Comments & Responses Report

Mercury Cluster: Ratpan Solar PV1

Comment received during the Initial Advertising Period

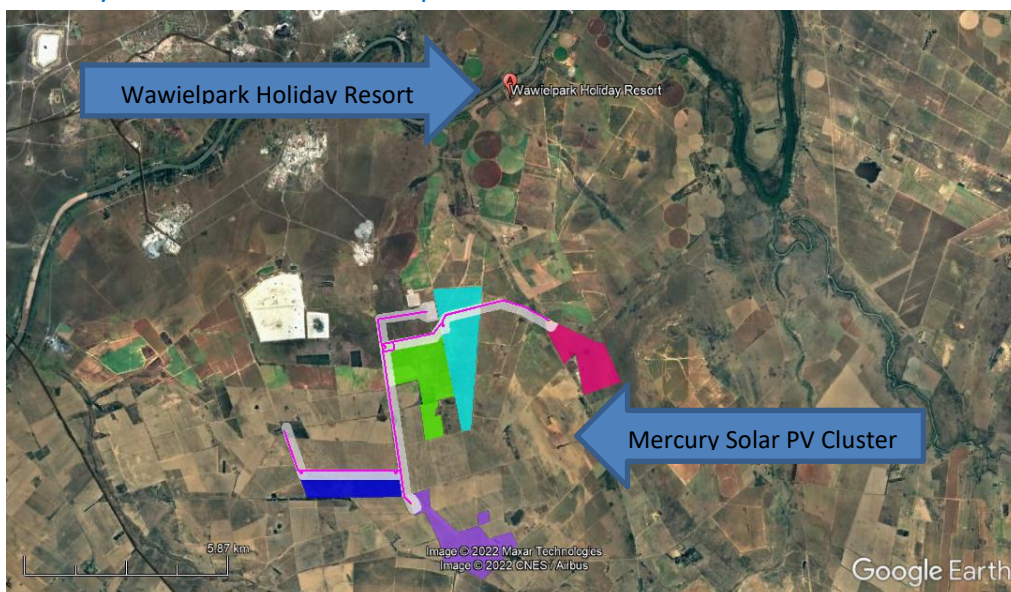
1. Mr Botha requested to be registered as an IAP
2. The kml files of the proposed development was requested
3. Mr Botha phoned Landscape Dynamics and explained that a special procedure needs to be followed when power lines crosses land belonging to a mine.

1. Mr Botha and the Harmony mine is a registered IAP.
2. The requested kml files were emailed to Mr Botha
3. It is Landscape Dynamics' understanding that the following two properties may be affected (the white blocks on the map below):
 - a. Remainder of the Farm, Moab, No 279
 - b. The Farm Zaiplaats, Portion 2, No 190
